**RE: Response to Comments**

**The Aurora Highlands Lennar Phase 1 – Site Plan – First Review**

**Application Number: DA-2062-61**

**Case Numbers: 2024-4018-00, 2024-3038-00**

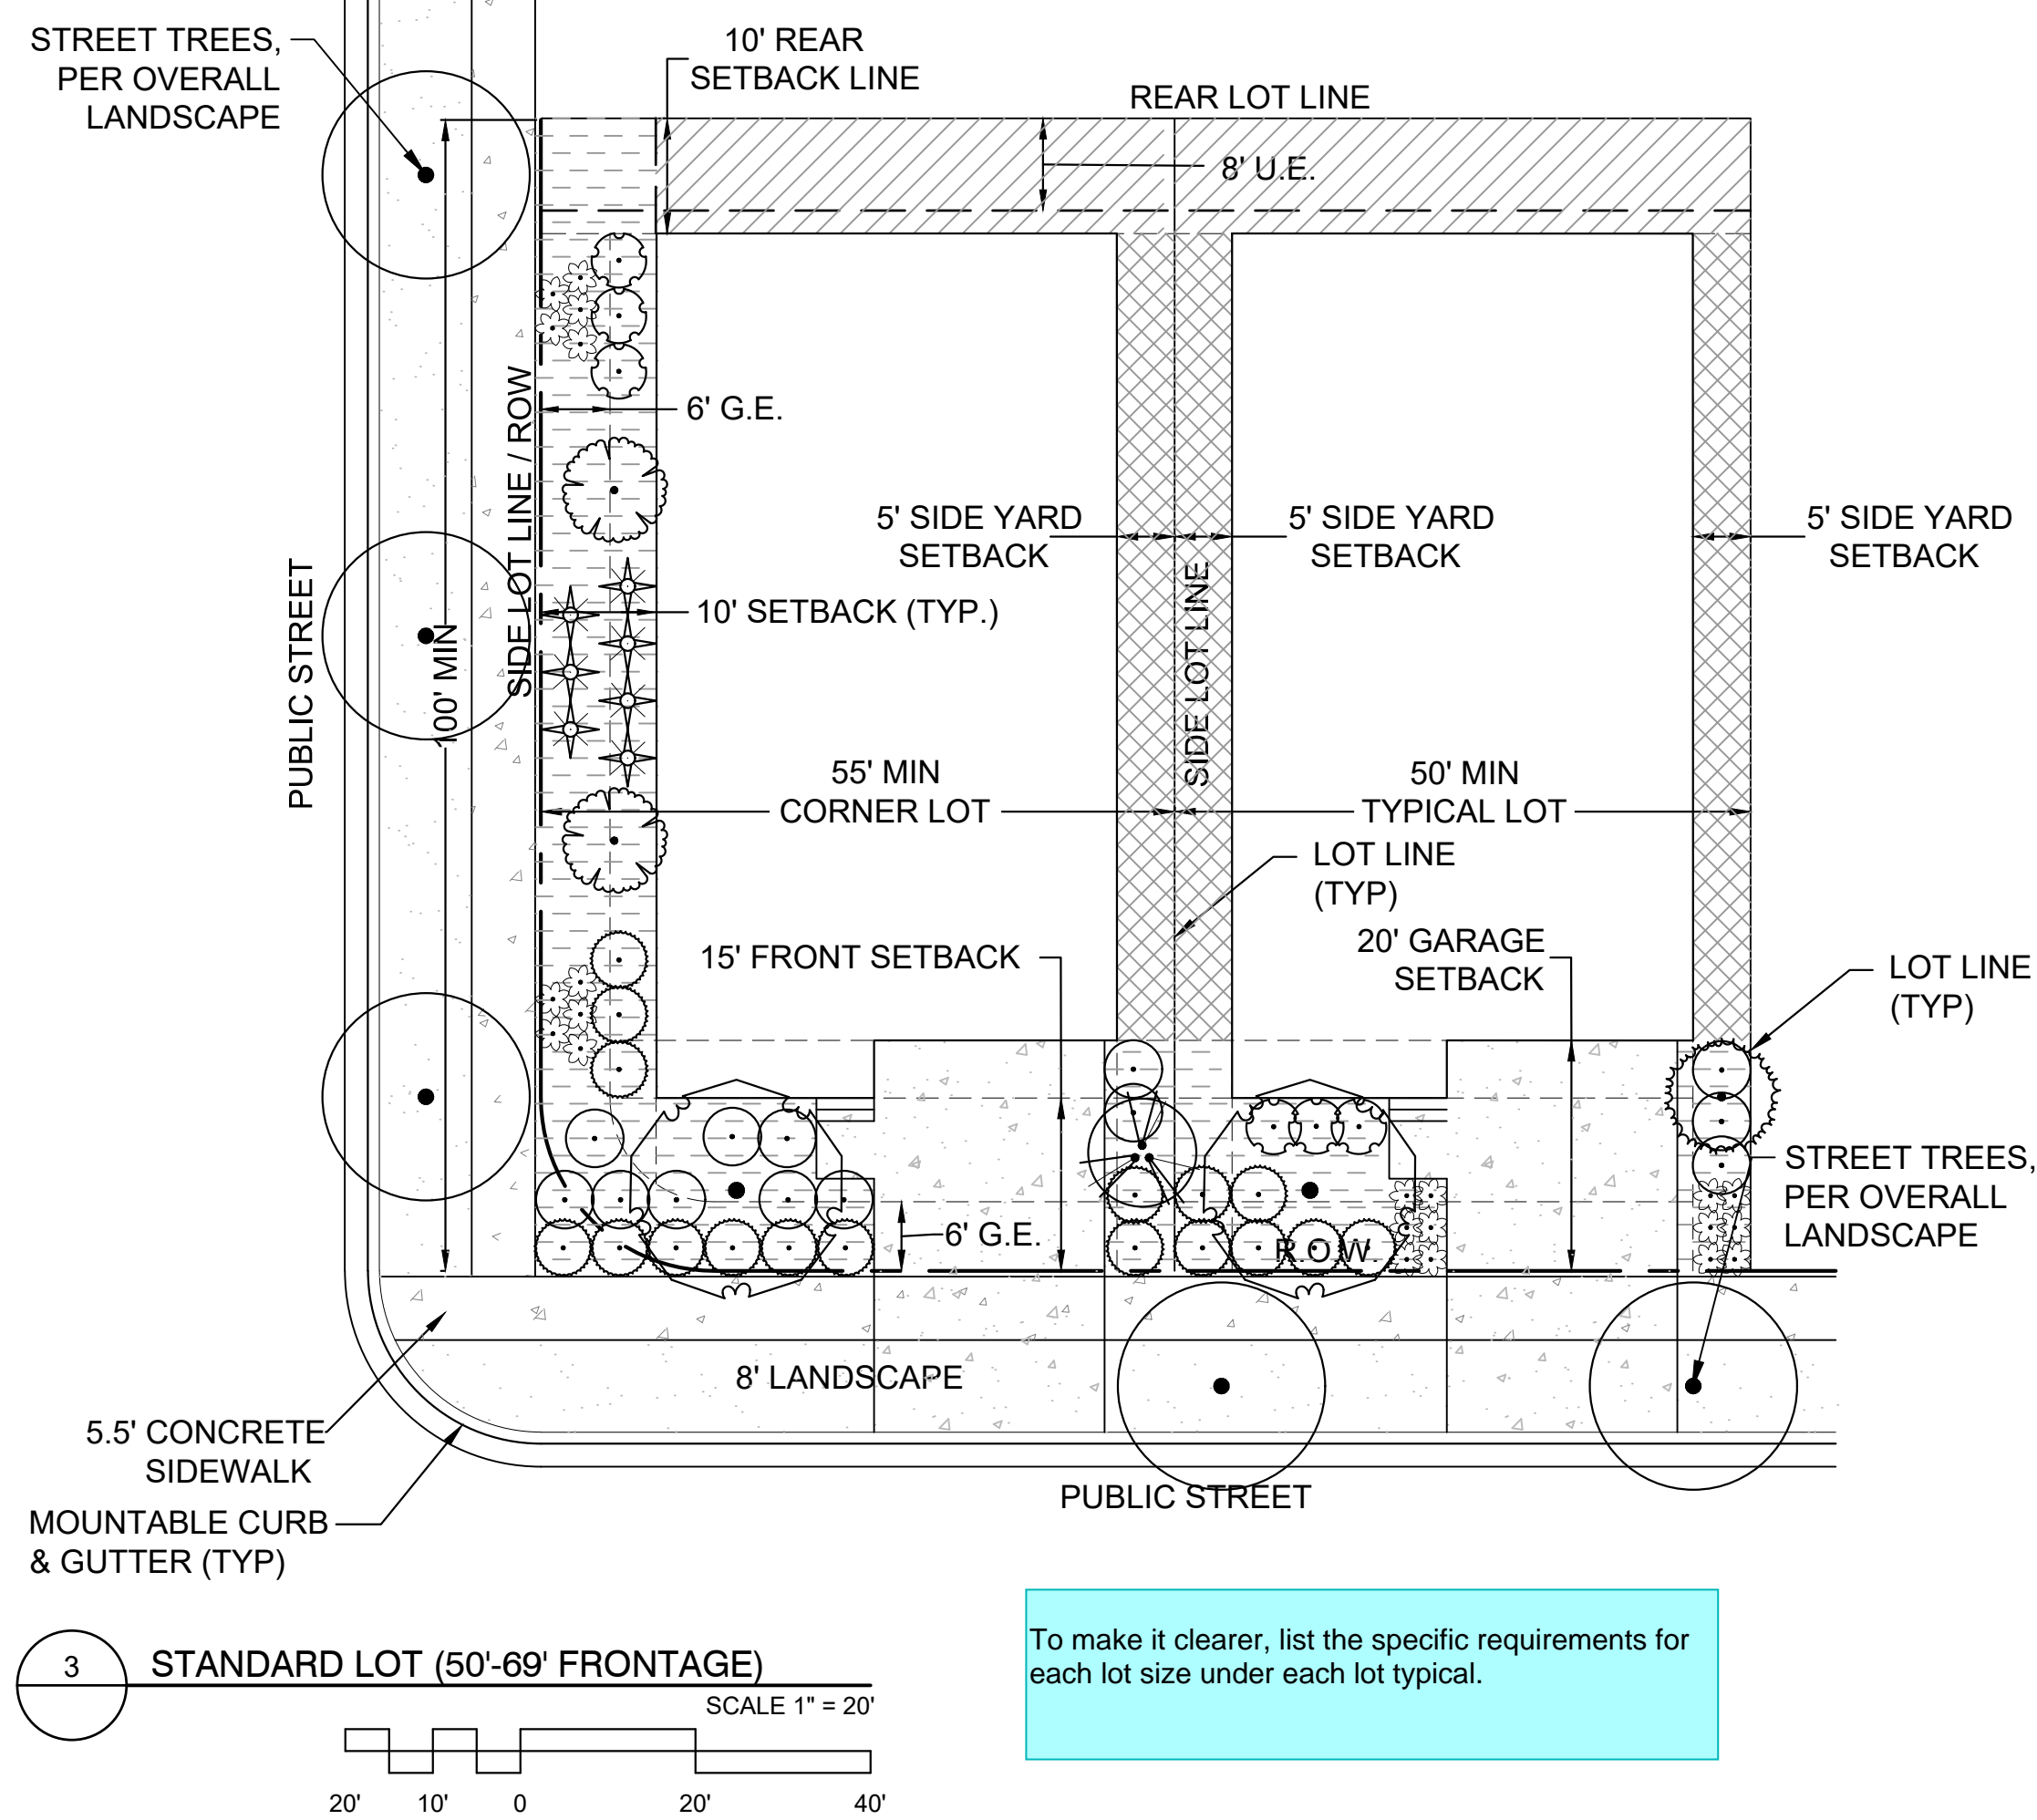
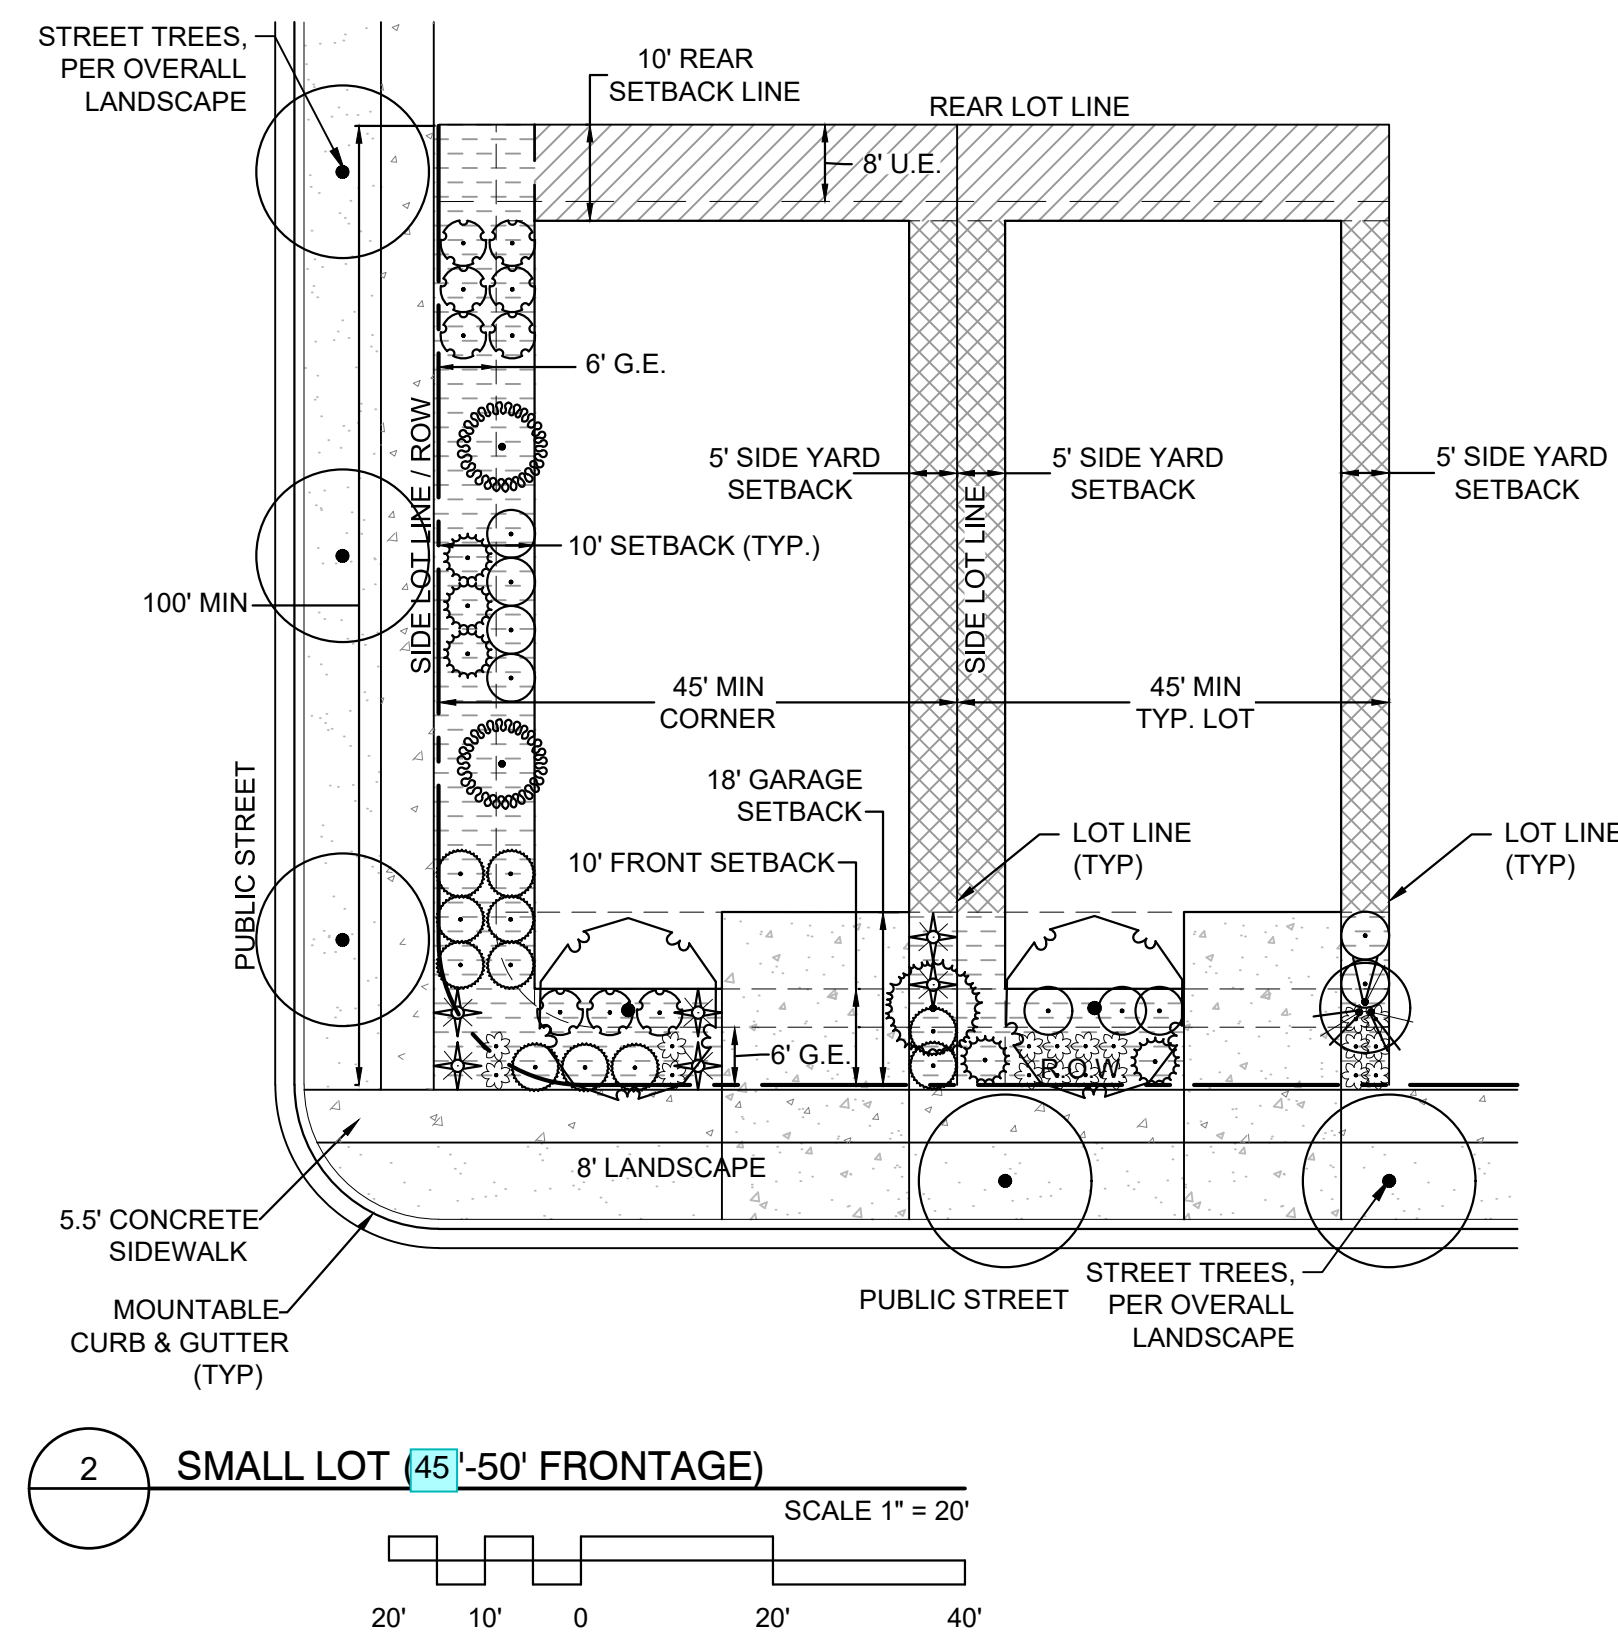
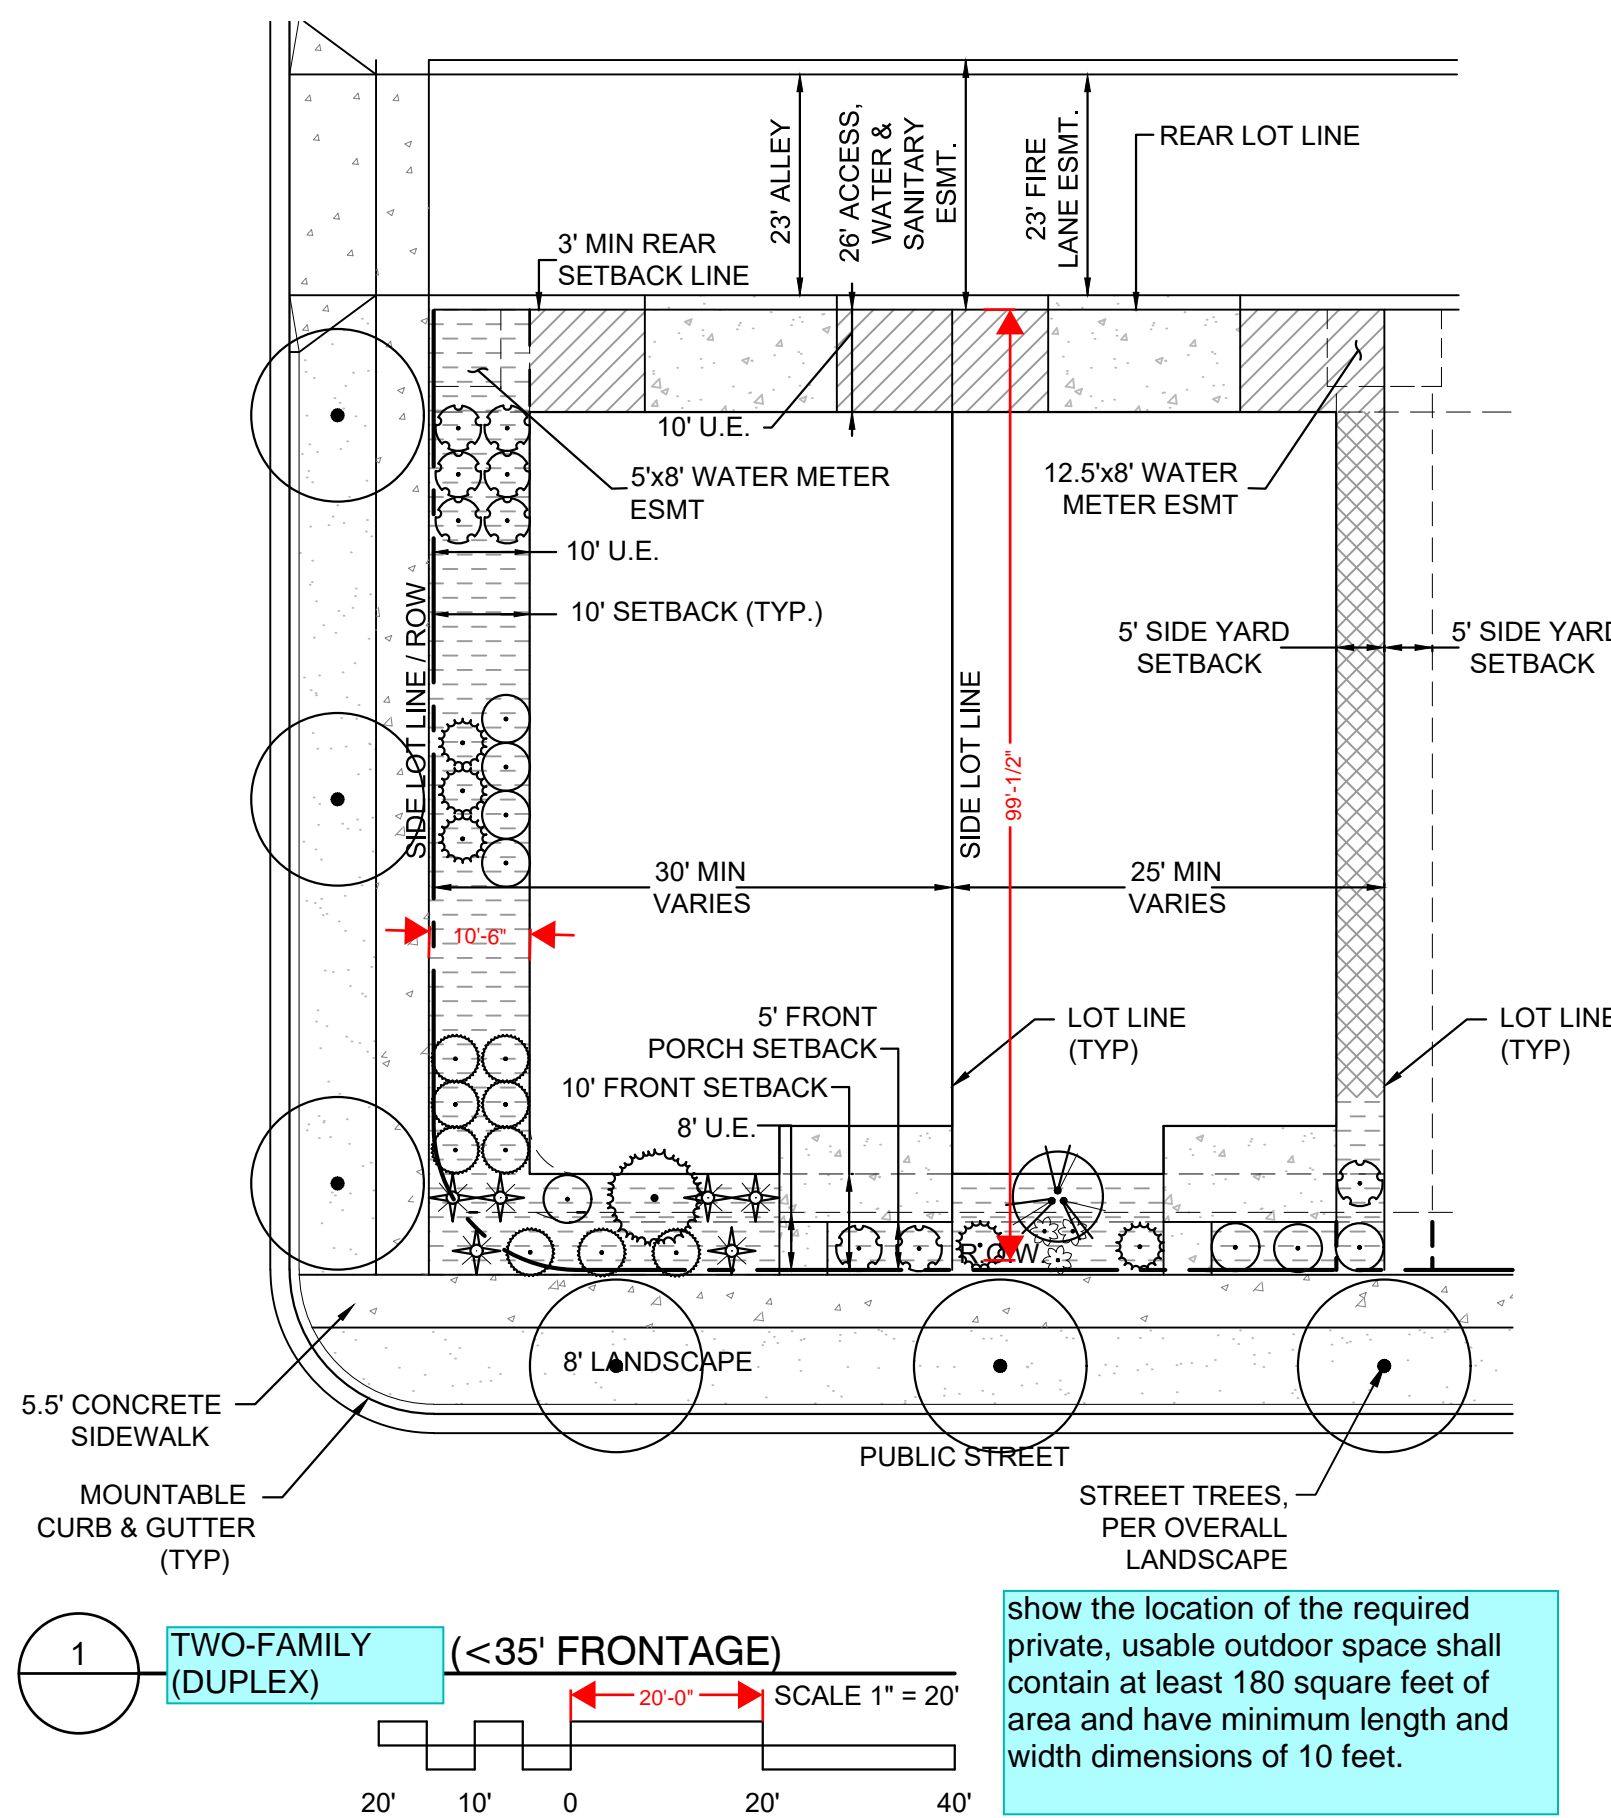
Show water and sanitary services in these details. Ensure minimum clearance are provided between landscaping items and the service lines and water meters

To make it clearer, list the specific requirements for each lot size under each lot typical.

rearrange so the lot requirements are on the same sheet as the lot typicals

Revise typicals per UDO requirements.

show the location of the required private, usable outdoor space shall contain at least 180 square feet of area and have minimum length and width dimensions of 10 feet.

***Response: Lot landscape requirements have been itemized under each lot typical. The required plant quantities per lot type are now on the same sheet as the typicals.***

***Response: Each small residential lot has a private outdoor space consisting of a minimum of 180 square feet.***
